Environmental Planning Commission

Staff Report

Agenda Number : 2
Project # : PR-2020-004457
Case # : SI-2021-00651
VA-2021-00145
Hearing Date: July 15, 2021

Agent	Rio Grande Engineering, LLC
Applicant	Barbara Mueller
Request	Site Plan-EPC, Variance-EPC
Legal Description	Tract 22, Volcano Cliffs Subdivision, Unit 6
Location	Quivira Drive, between Vista Vieja, and Retablo (No address is currently assigned)
Size	Approximately 8.0 acres
Zoning	R-A

TYPICAL LOT LANDSCAPING PLAN

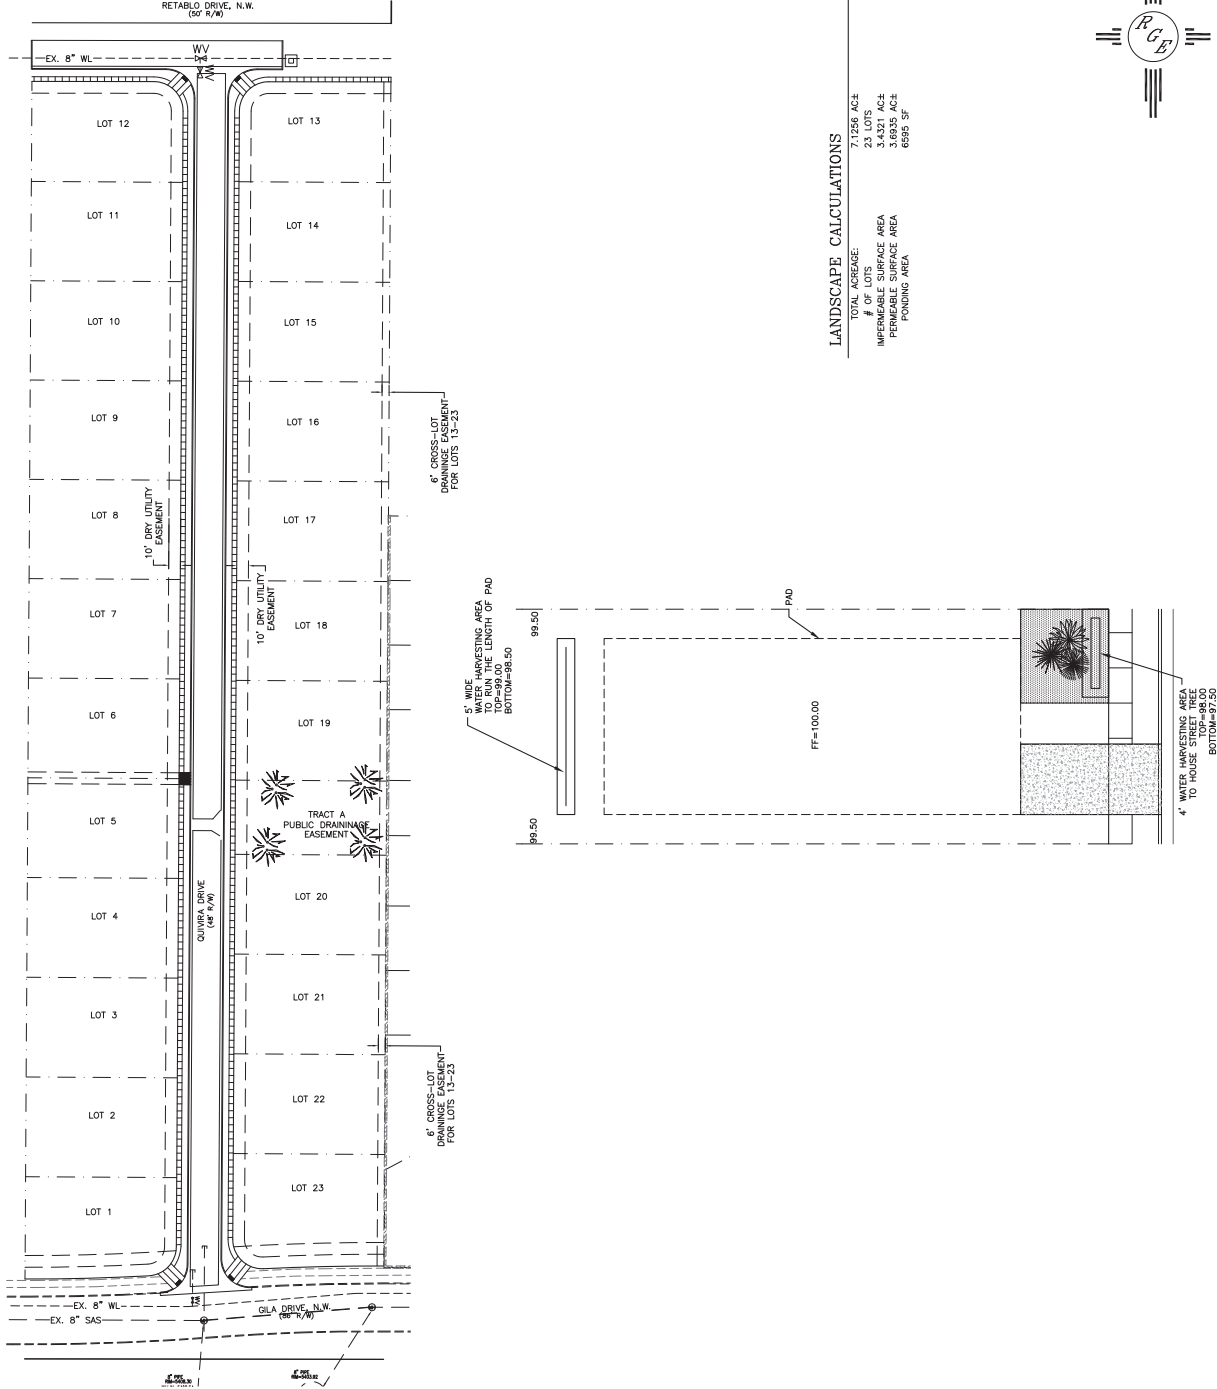
- B. The landscaping plan shall remove all notes referring to the 15% minimum landscape requirement, as it is not required in single-family residential development.

- C. The note “Landscape plan shall adhere to IDO subsection 5-6(C)(4) through IDO subsection 5-6(C) (10)” shall be removed.

PERIMETER SCREEN WALL DETAIL WHICH ABUTS MAJOR PUBLIC OPEN SPACE

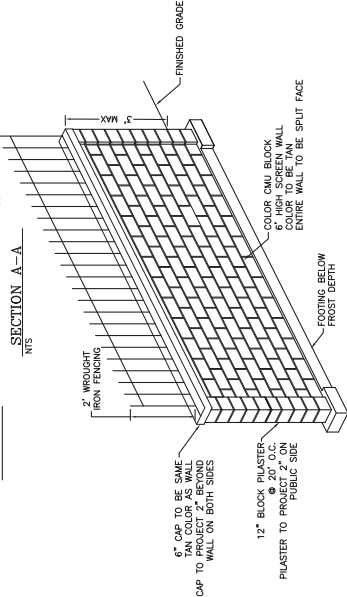
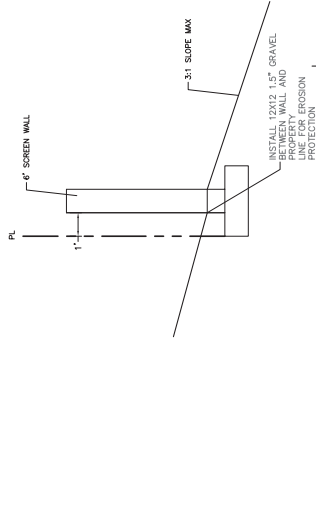
Detail for perimeter walls abutting MPOS shall be revised to correct conflicting heights. A keyed note reads “6-foot high screen wall”, but the dimension shows a maximum height of 3-feet.
